**SUBDIVISION,
PLANNED UNIT DEVELOPMENT,
PLANNING APPROVAL, &
REZONING STAFF REPORT**

Date: November 19, 2009

McGill-Toolen High School Subdivision, Phase 2

Subdivision Approval to create one legal lot of record from three metes and bounds parcels; Planned Unit Development Planning Approval, and Rezoning to amend Master Plan to allow new student center and parking lot.

SUBDIVISION DETAIL

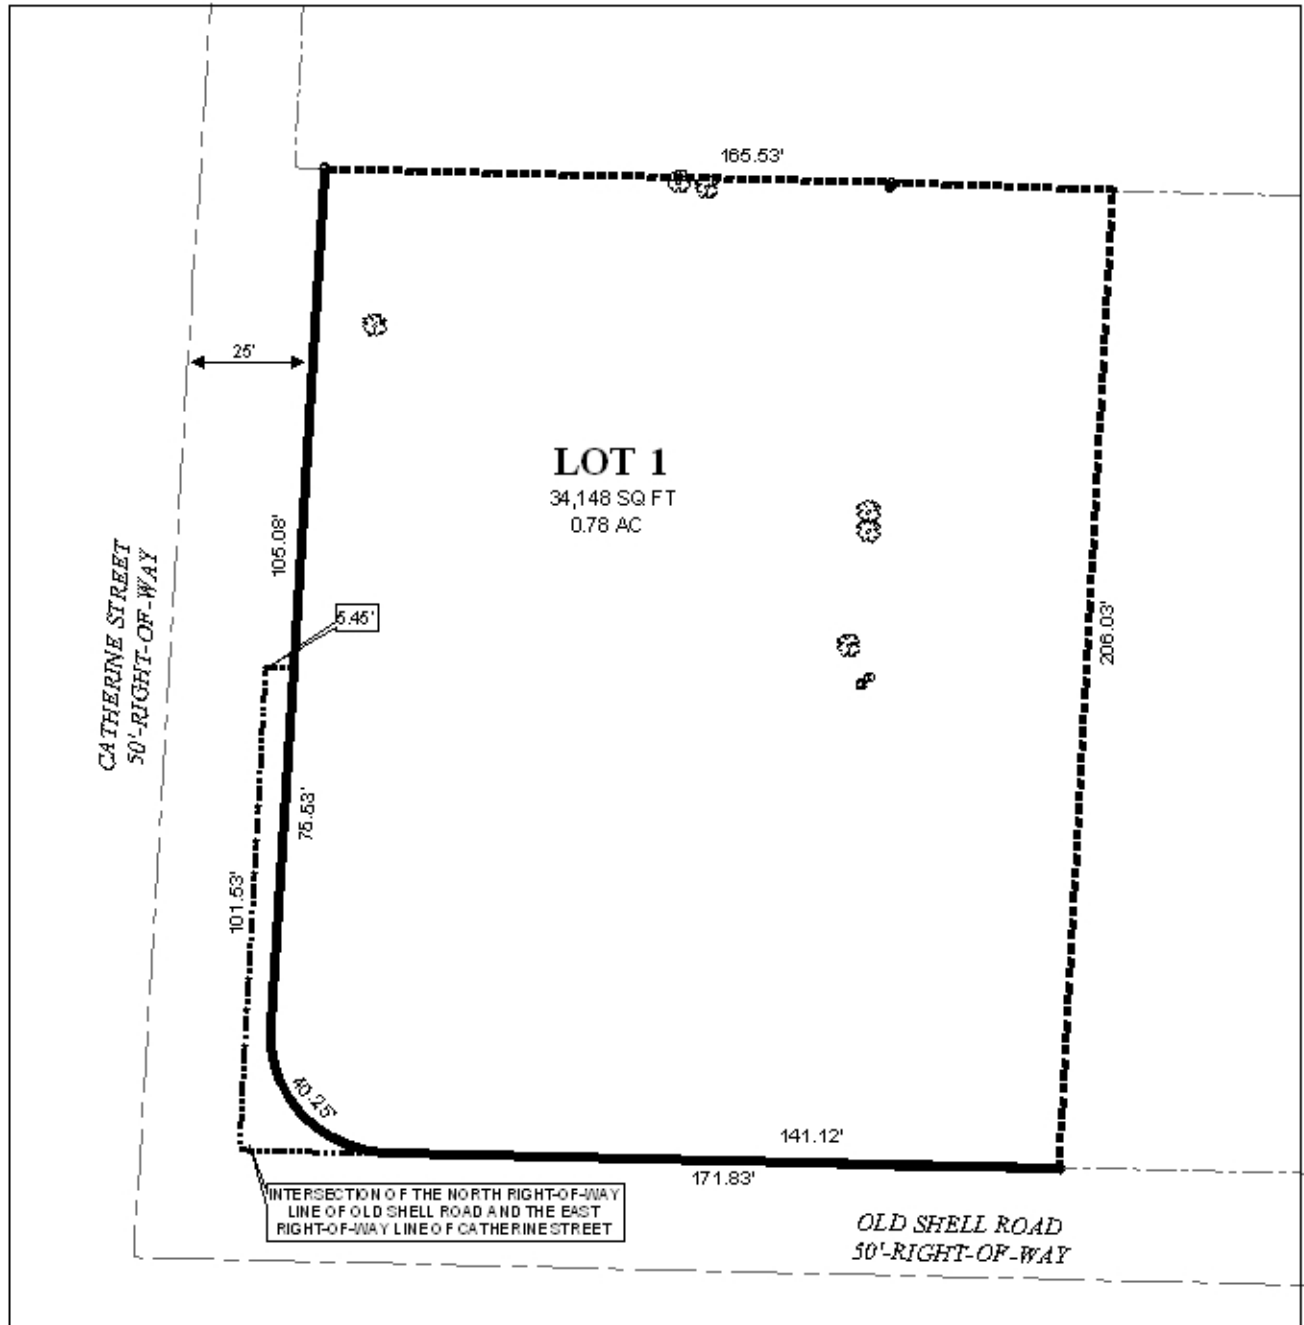
It appears that the applicant has dedicated some right-of-way at the intersection of North Catherine Street and Old Shell Road, so as to comply with Section V.B.16 of the Subdivision Regulations regarding curb radii; however, it is not labeled as such. The applicant should revise the plat accordingly.

The applicant should also revise the plat to illustrate a 25' minimum building setback line from each street.

- 3) provision of adequate radius, in compliance with Section V.B.16 of the Subdivision Regulations, at the intersection of North Catherine Street and Old Shell Road;
